TECH. SPEC. PAGE - 36 -

4.2.7 Waste Disposal

FIGURE 4

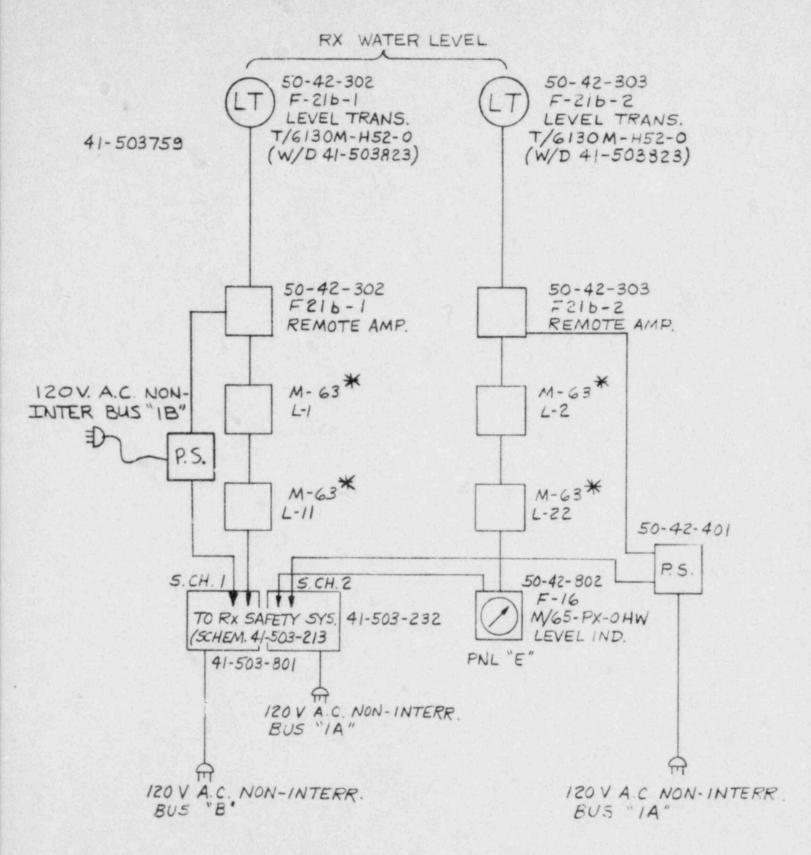
* PROPOSED MODIFICATION
